R I D G E V I E W

J U N E A U , A L A S K A

Changes to the Preliminary Plan

Revisions to 11/14/2022 ARF Application

ARF Attachment C.Rev 1

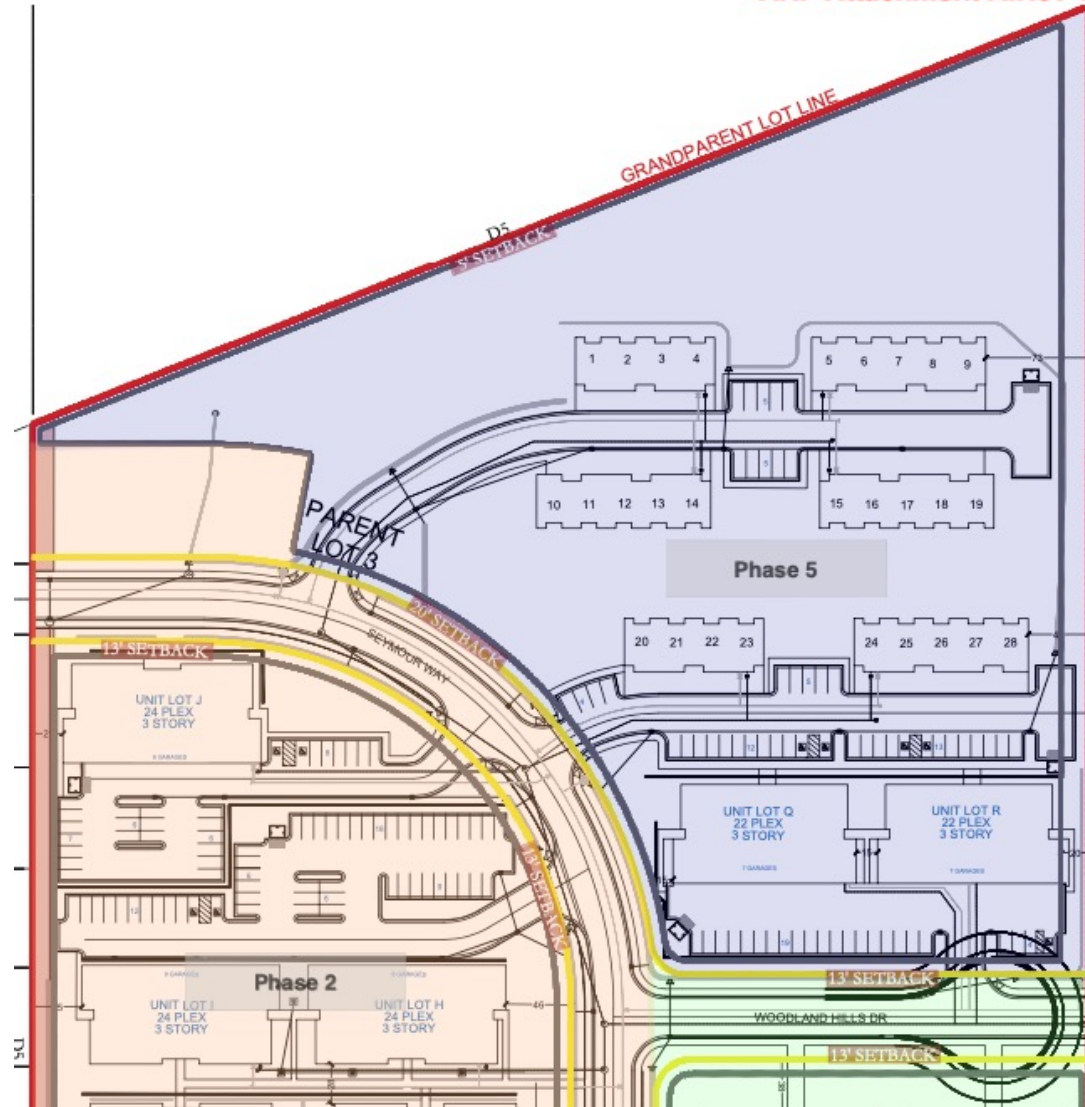
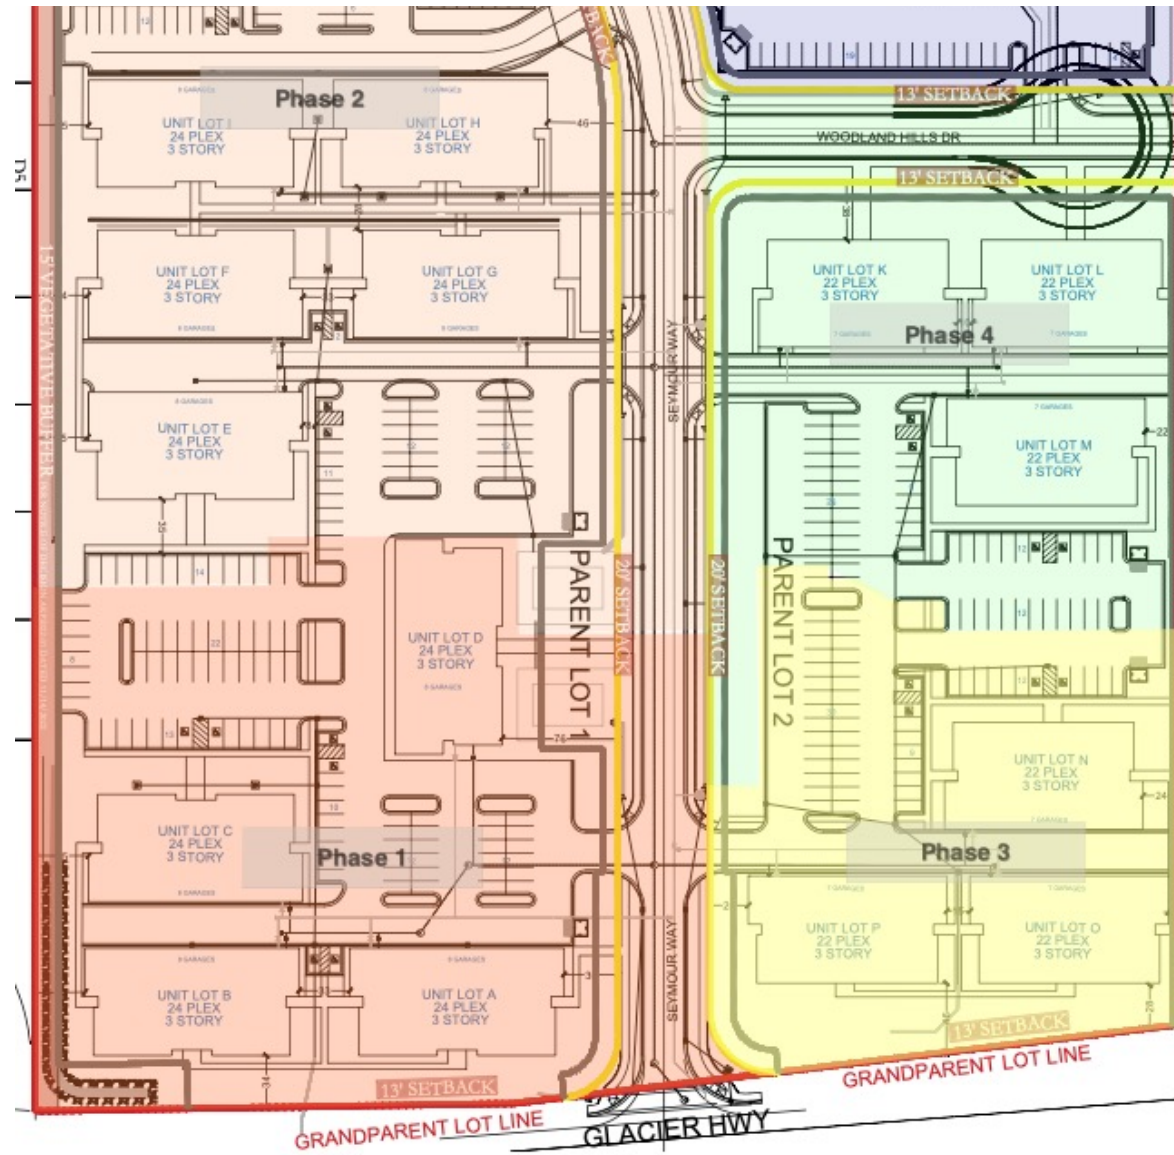
1. Minimal changes to Open Space & Parking (still exceed CBJ required minimums)
2. Moved Unit Lot D to Phase 1 (72 units vs. 96 units)
3. Staff recommendation for unique name (Seymour Way)
